Access Compliance Report

Intersection ID: 9707	Main Street: BRAWLEY_LN	Cross Street: STONE_ABBEY_PL	Location: SW
ADA ID: C328772183B8	Ramp Type: Perp	Initial Pass/Fail: Fail	Overall Compliance: No
			Severity Score: 21.25

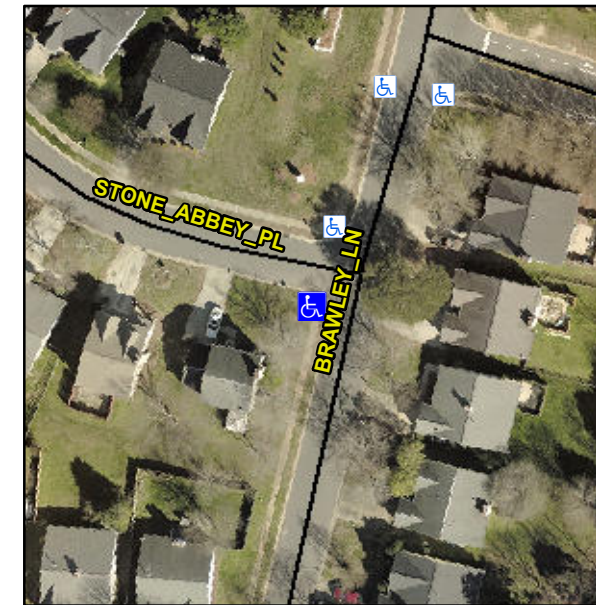
Not Found, R304.5.1, R304.2.2

Compliance	Description	Data	Compliance	Description	Data
N/A	Ramp Length (in)	68.0	No	Ramp Slope (%)	9.7
No	Ramp Width (in)	47.5	Yes	Ramp XSlope (%)	1.4
N/A	Flare Type LT	N/A	N/A	Flare Type RT	N/A
N/A	Flare Slope LT (%)	N/A	N/A	Flare Slope RT (%)	N/A
N/A	Flare Traversable LT?	N/A	N/A	Flare Traversable RT?	N/A
N/A	Landing Length (in)	N/A	N/A	DWS Provided?	N/A
N/A	Landing Width (in)	N/A	N/A	DWS Contrast?	N/A
N/A	Landing Slope (%)	N/A	N/A	DWS Length (in)	N/A
N/A	Landing X Slope (%)	N/A	N/A	DWS Full Width?	N/A
N/A	Landing Curb? (Y/N)	N/A	N/A	DWS Offset (in)	N/A
N/A	Shared Landing?	N/A			
N/A	Gutter Ponding?	N/A	N/A	Gutter Slope (%)	N/A
N/A	Gutter Lip Ht (in)	N/A	N/A	Gutter X Slope (%)	N/A
N/A	Painted X Walk1?	No	N/A	Painted X Walk2?	N/A
	X Walk 1 Direction	To NE		X Walk 2 Direction	N/A
N/A	X Walk 1 Width (in)	N/A	N/A	X Walk 2 Width (in)	N/A
	X Walk 1 Slope (%)	0.4		X Walk 2 Slope (%)	N/A
	X Walk 1 X Slope (%)	0.3		X Walk 2 X Slope (%)	N/A

Remove & Replace Entire Ramp.
